SERVICE INFORMATION NO. SI 42NG-056/1

Austro Engine Mandatory Service Bulletin No. MSB-E4-007/6
ATA-Code: 71-00

MANDATORY SERVICE BULLETIN

Replacement of Waste Gate Controller

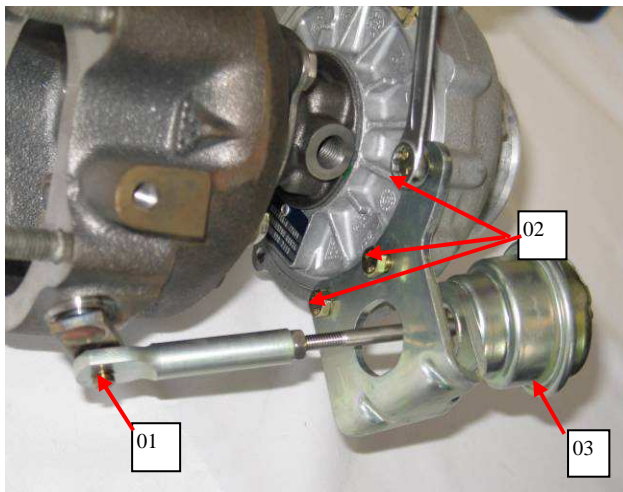
1. Disconnect Hose at the top of the Waste Gate Controller
2. Remove three M6 Bolts [02]
3. Remove Circlip [01]
4. Disconnect rod from waste gate lever and remove waste gate controller [03]

Install new Waste Gate Controller according to table section 3.1.
